APPLICATION NO.	FILING DATE	FIRST NAMED INVENTOR	ATTORNEY DOCKET NO.	CONFIRMATION NO.
09/674,039	10/25/2000	Yasuo Himuro	Q59956	9058

Advisory Action

advisory action attachment

I - I section

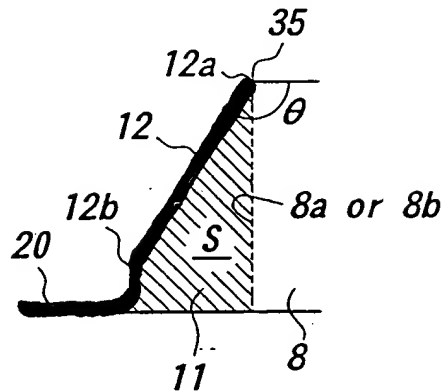
Applicant argues that Europe 310 fails to teach a pseudo-land portion formed in the circumferential groove. In support of this argument, applicant asserts that the side of the circumferential groove is not defined by the pseudo land portion. First: The scope and meaning of pseudo land portion remains unclear. As such, no conclusion can be made that the side of the circumferential groove is not defined by the pseudo land portion. Second: Applicant's assertion is incorrect and applicant's arguments regarding Europe '310 are consequently not persuasive. A copy of the applicant's figure 2a is presented below:

The red color has been added to applicant's figure 2a by the examiner and indicates the bottom and sidewall of the groove at the cross section I-I. As can be seen from applicant's figure 2a, the bottom of the groove at cross section I-I is the red surface 20 and the sidewall of the groove at cross section I-I comprises red surface 12 of the pseudo land portion. The sidewall of the groove at cross section I-I is defined by the slant surface 12 of the pseudo land portion. It is acknowledged that surface 12 in applicant's figure 2a is "a surface extending from the ground contacting surface of a land portion toward the groove bottom". Europe '310 teaches such a surface since the upper surface of each beveled portion is "a surface extending from a ground contacting surface of a land portion toward the bottom of a groove".
